Access Compliance Report

Public Rights-of-Way

Intersection ID: 30330	Main Street: HIDDEN_STREAM_CT	Cross Street: TOM_HUNTER_RD	Location: NE
ADA ID: 6A2C367694C7	Ramp Type: PerpDiag	Initial Pass/Fail: Fail	Overall Compliance: No
Codes/Mitigation Info/Possible Solution		Field Measurements/Component Compliance

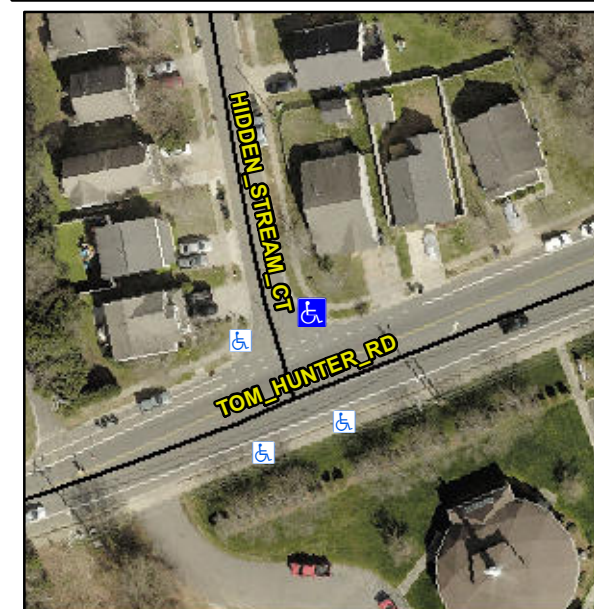
Not Found, R304.5.1

Compliance	Description	Data	Compliance	Description	Data
N/A	Ramp Length (in)	46.0	Yes	Ramp Slope (%)	7.1
No	Ramp Width (in)	42.0	Yes	Ramp XSlope (%)	0.8
N/A	Flare Type LT	N/A	N/A	Flare Type RT	N/A
N/A	Flare Slope LT (%)	N/A	N/A	Flare Slope RT (%)	N/A
N/A	Flare Traversable LT?	N/A	N/A	Flare Traversable RT?	N/A
N/A	Landing Length (in)	N/A	N/A	DWS Provided?	N/A
N/A	Landing Width (in)	N/A	N/A	DWS Contrast?	N/A
N/A	Landing Slope (%)	N/A	N/A	DWS Length (in)	N/A
N/A	Landing X Slope (%)	N/A	N/A	DWS Full Width?	N/A
N/A	Landing Curb? (Y/N)	N/A	N/A	DWS Offset (in)	N/A
N/A	Shared Landing?	N/A			
N/A	Gutter Ponding?	N/A	N/A	Gutter Slope (%)	N/A
N/A	Gutter Lip Ht (in)	N/A	N/A	Gutter X Slope (%)	N/A
N/A	Painted X Walk1?	No	N/A	Painted X Walk2?	No
	X Walk 1 Direction	To W		X Walk 2 Direction	To S
N/A	X Walk 1 Width (in)	N/A	N/A	X Walk 2 Width (in)	N/A
	X Walk 1 Slope (%)	3.0		X Walk 2 Slope (%)	1.3
	X Walk 1 X Slope (%)	1.5		X Walk 2 X Slope (%)	2.8

Remove & Replace Curb Ramp With Two New Directional Ramps or Equivalent.
